**LEVY NUCLEAR PLANT, UNITS 1 AND 2
DOCKET NOS. 52-029 AND 52-030**

**REVISION TO RESPONSE TO REQUEST FOR ADDITIONAL INFORMATION LETTER NO. 087
RELATED TO SEISMIC DESIGN PARAMETERS**

Levy Nuclear Plant Units 1 and 2
Response to NRC Request for Additional Information Letter No. 087 Related to
SRP Section 3.7.1 for the Combined License Application, dated March 17, 2010

Figure RAI 03.07.01-02-1, Conceptual Grading Plan (1 page)

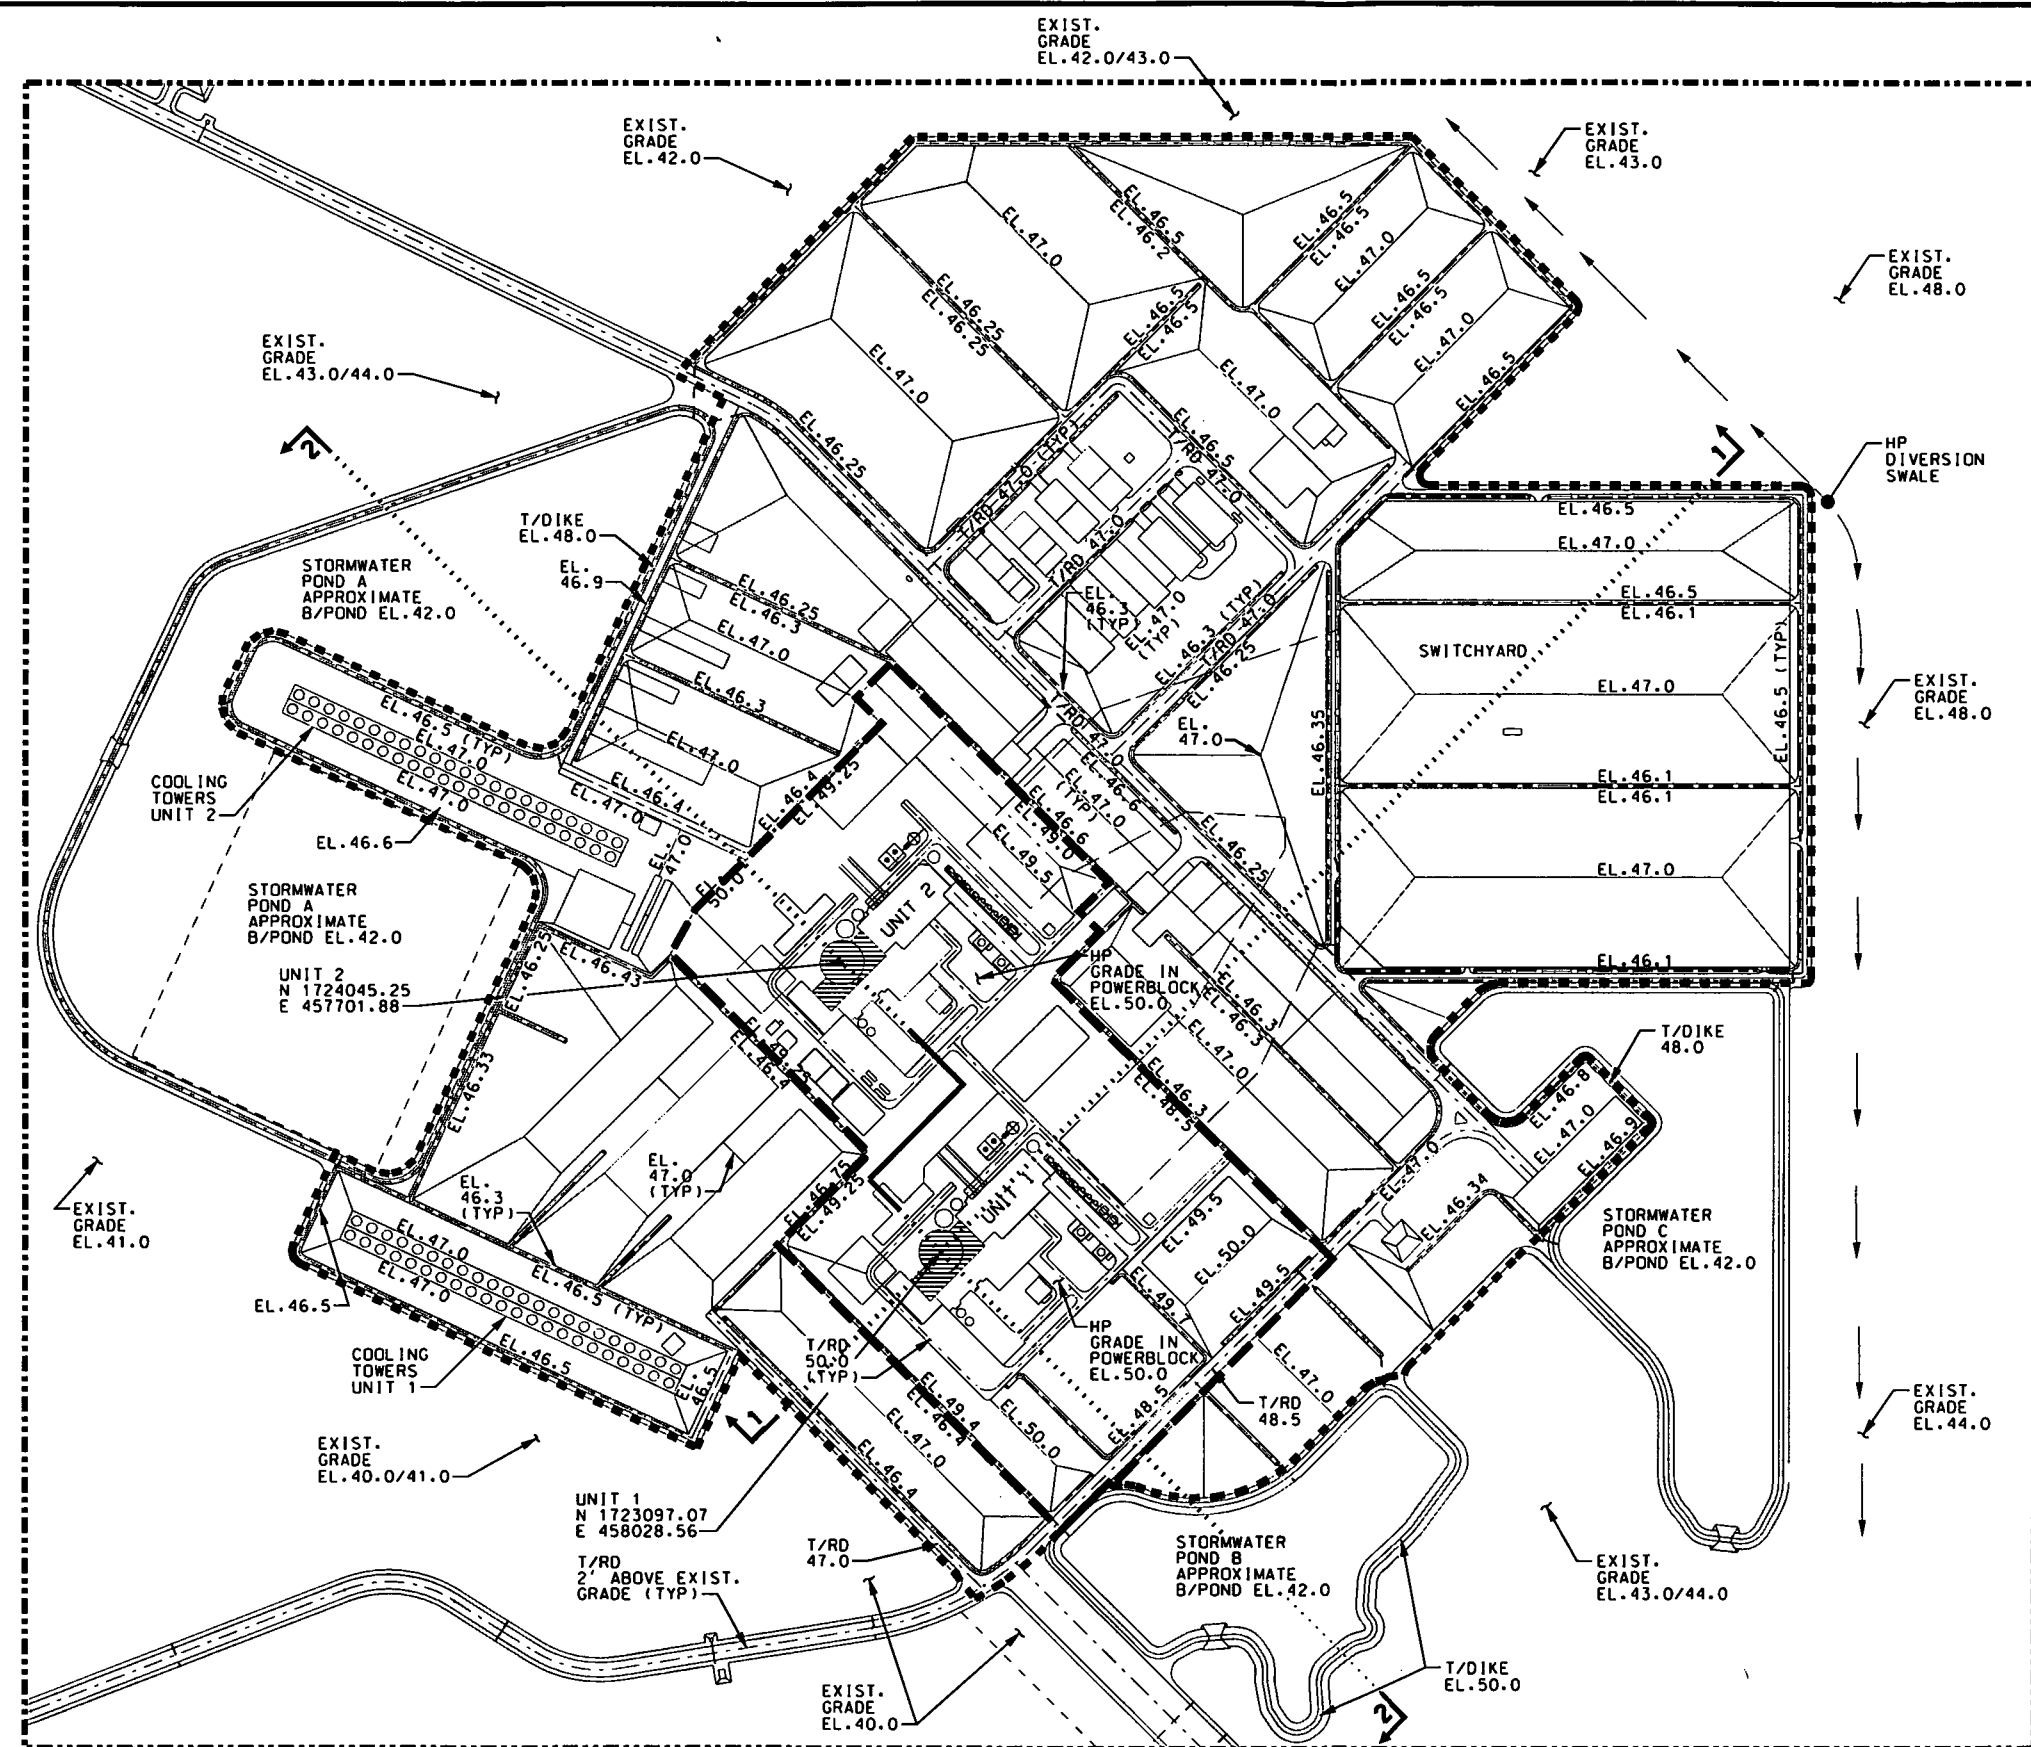
In the applicant's response to Question 03.07.01-1 of RAI 2318 (NRC Letter No. 046), the applicant describes the approach used to develop revised site specific seismic ground motions (response spectra). These analyses include engineered fill as part of the soil columns used to develop the ground surface spectra. However, it is not clear from the discussion what the extent of the changes to the site (excavation and placement of engineered fill) are planned and if these changes are to such an extent as to affect the seismic ground motion. Thus, the staff is requesting the applicant to provide information regarding the extent of planned excavation and placement of engineered backfill and an assessment of whether these changes are sufficiently extensive such that the surface ground motion would be modified. Additionally, please provide a discussion that summarizes the planned construction sequence of removal of near surface soils, placement of engineered fill, drilled shaft installation for adjacent structures, construction of the diaphragm wall, and excavation of soil material beneath the NI structures as it relates to potentially changing the ground motion as is inferred by incorporating the engineered fill in the SSI soil columns.

Figures RAI 03.07.01-02-1 and RAI 03.07.01-02-2 show the conceptual grading plan and the conceptual grading section for the LNP site respectively. The plant Nuclear Island (NI) footprint (approximately 0.8 acres for each unit) is small compared to the approximately 347 acres where fill will be placed to raise the existing grade level. The existing grade in the plant footprint area is at approximate elevation 12.8 m (42 ft.) NAVD88. The finished grade in the 347 acre fill area will vary from elevation 15.2 m (50 ft.) NAVD88 to elevation 14.3 m (47 ft.) NAVD88. The grading is designed to prevent flooding of the work area during construction and plant operation.

Figures RAI 03.07.01-02-1 and RAI 03.07.01-02-2 show the conceptual grading plan and the conceptual grading section for the LNP site respectively. The plant Nuclear Island (NI) footprint (approximately 0.8 acres for each unit) is small compared to the approximately 347 acres where fill will be placed to raise the existing grade level. The existing grade in the plant footprint area is at approximate elevation 12.8 m (42 ft.) NAVD88. The finished grade in the 347 acre fill area will vary from elevation 15.2 m (50 ft.) NAVD88 to elevation 14.3 m (47 ft.) NAVD88. The large extent of the fill area compared to the NI footprint and because the PBSRS is higher than the GMRS for the LNP site, inclusion of the fill to design grade for the free field response analysis and the SSI analysis is appropriate.
